MCPB No. 12-39
Preliminary Plan No. 120100270

7206 Meadow Lane

RESOLUTION

RE: Appeal – May 2, 2014 Notice of Violation

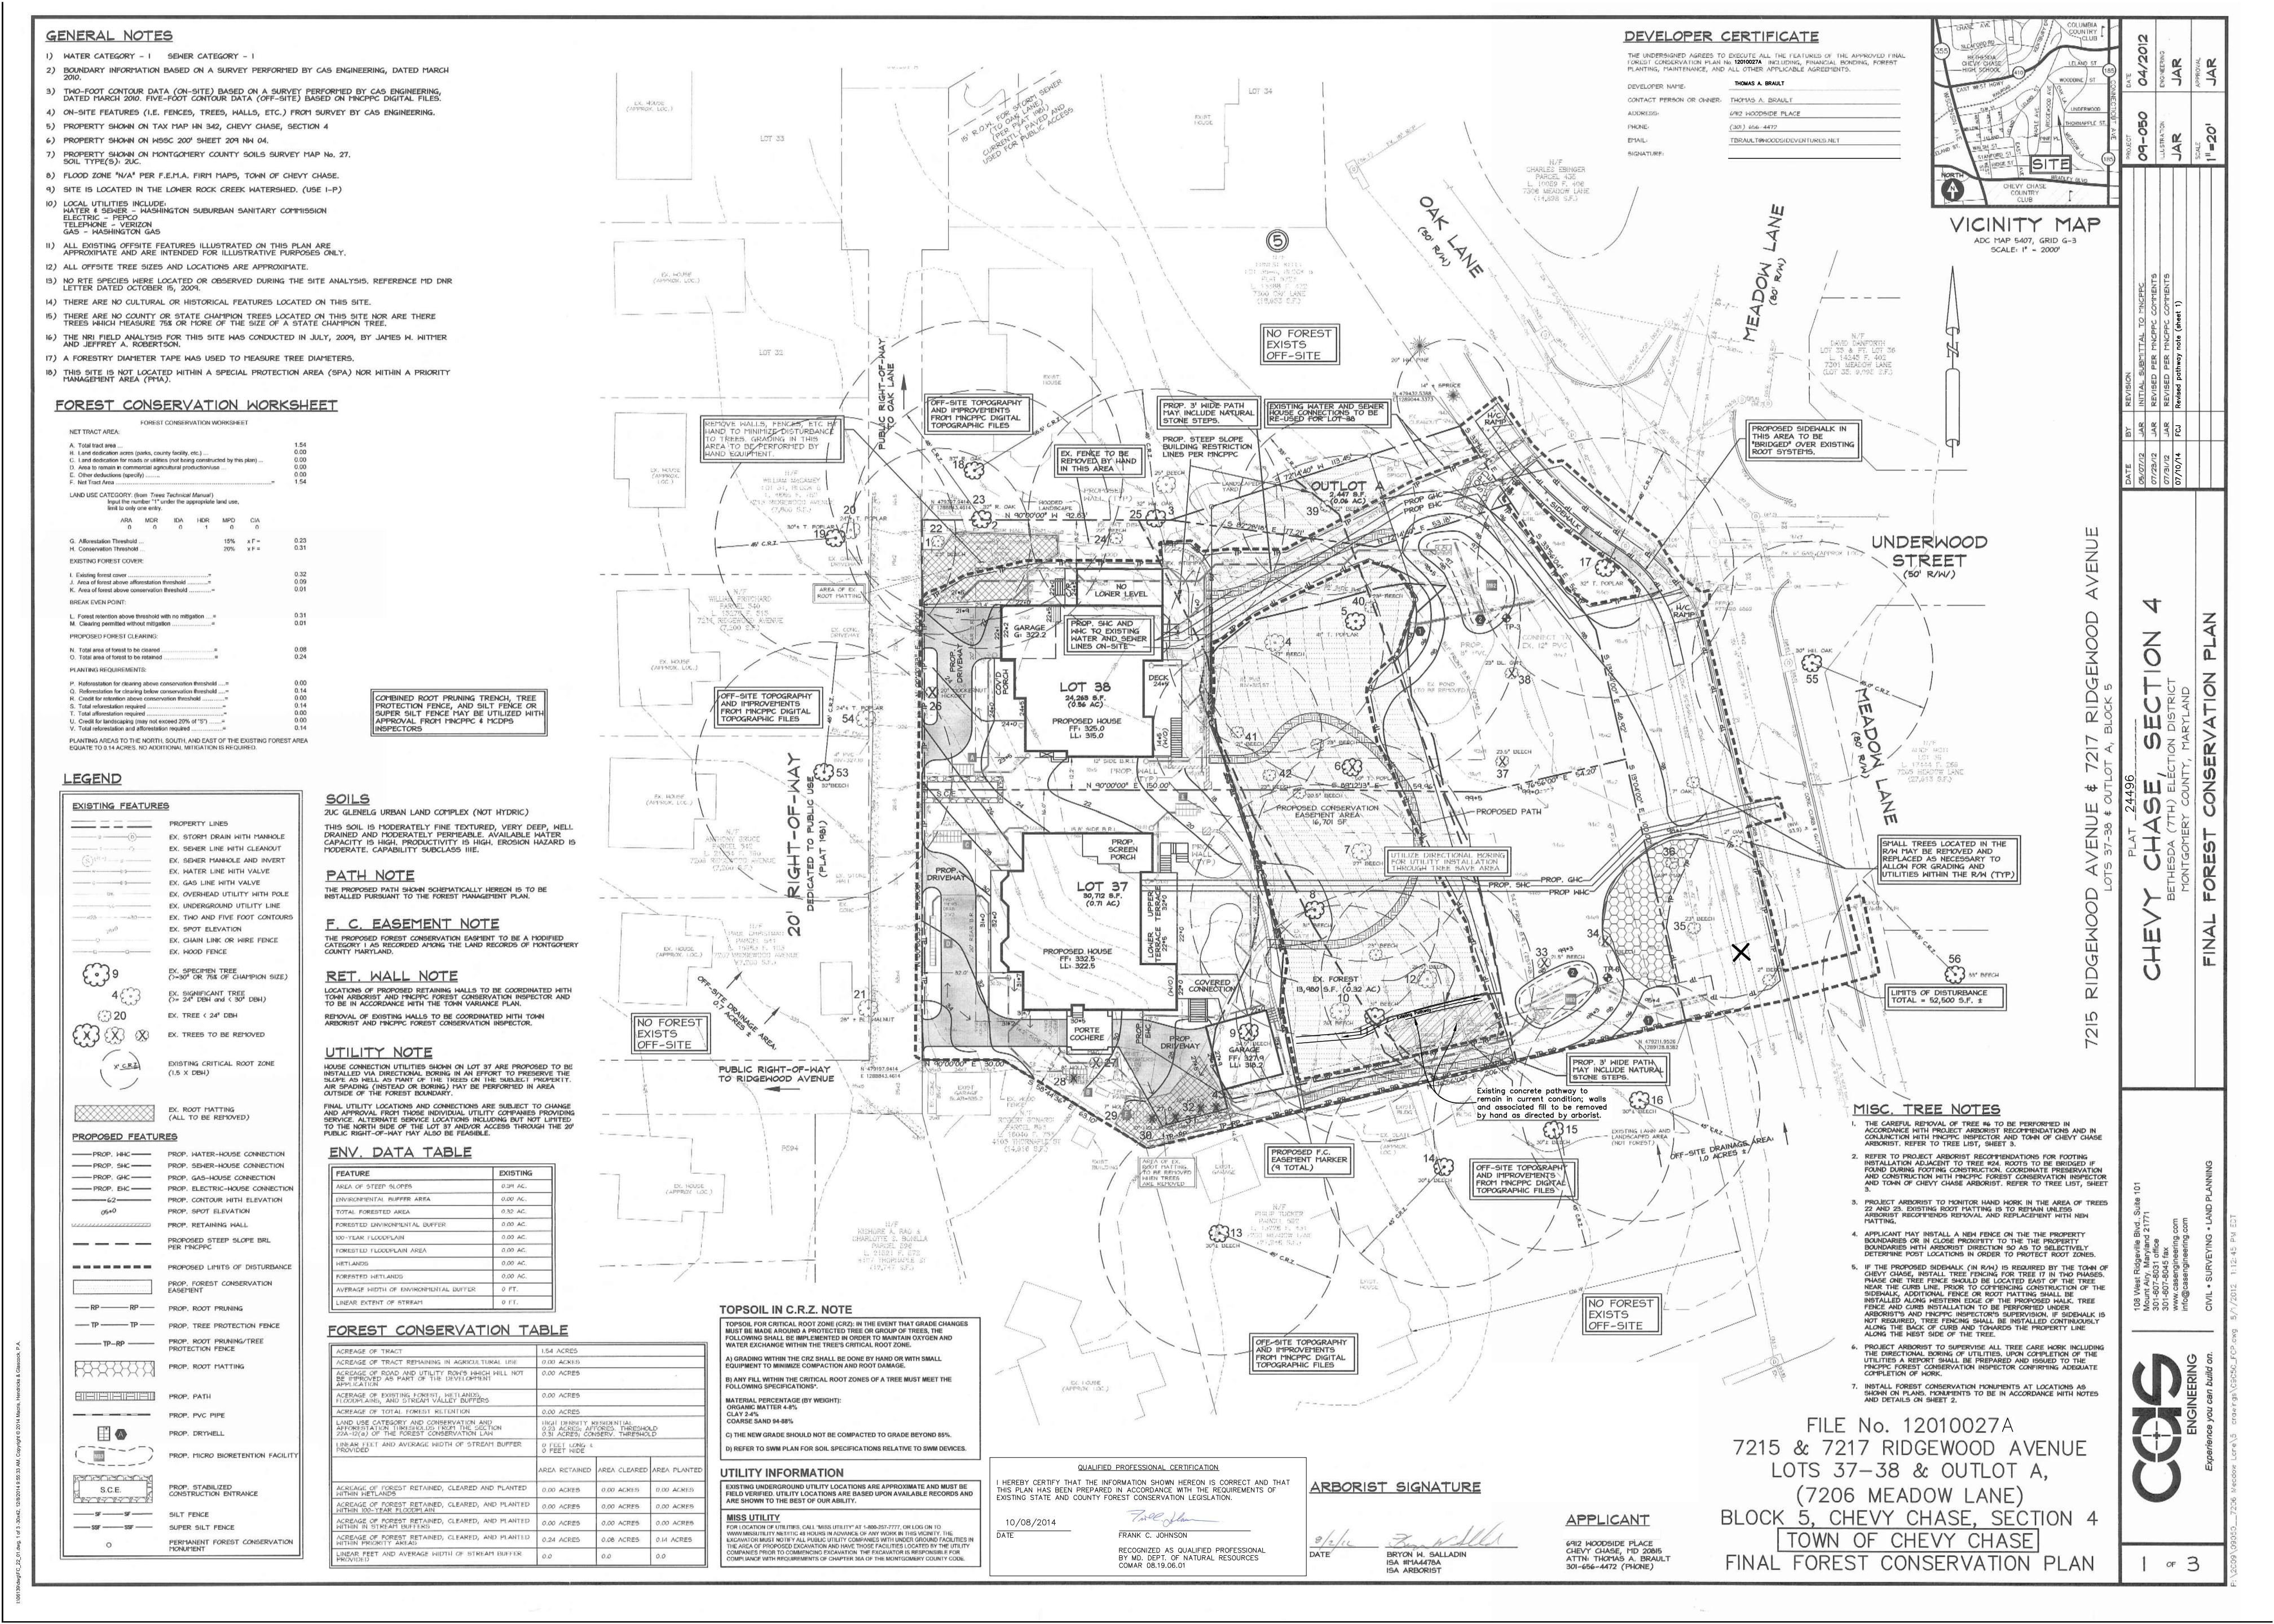
The FCP shows an existing concrete walk that is at least 45 feet long on lot 37. The FCP, which was approved on August 17, 2012, and signed by you indicating that you "the undersigned agrees to execute all the features of the approved final forest conservation plan No. 120100270 including, financial bonding, forest planting, maintenance, and all other applicable agreements" needs to be complied with. Item 10 of the Category I Conservation Easement does state that "except for the paths (two for each of Lots 37 and 38 as shown on the FCP), the 3-feet in width, unpaved paths or trails consistent with the purposes of the Easement may only be created after written approval from the Planning Director. Unpaved paths as identified and shown on the FCP may be continued and maintained."

In your May 31, 2014 appeal letter you request permission to allow the path, which is labeled as an existing concrete walk to remain. The FCP explicitly indicates that the walkway on lot 37 "ex. walls, walks, etc. to be removed by hand as directed by arborist". The retention of the existing concrete walk is inconsistent with item 10 in the conservation easement for that item allows for unpaved paths. As the Planning Director's designee on all enforcement matters, your request is denied. Therefore, those walls and walkways must be removed.

With this letter I am granting you an extension to July 10, 2014 to complete the corrective actions identified in the NOV dated May 2, 2014. If the corrective actions are not completed by July 11, 2014 additional enforcement actions, including civil administration citations will be
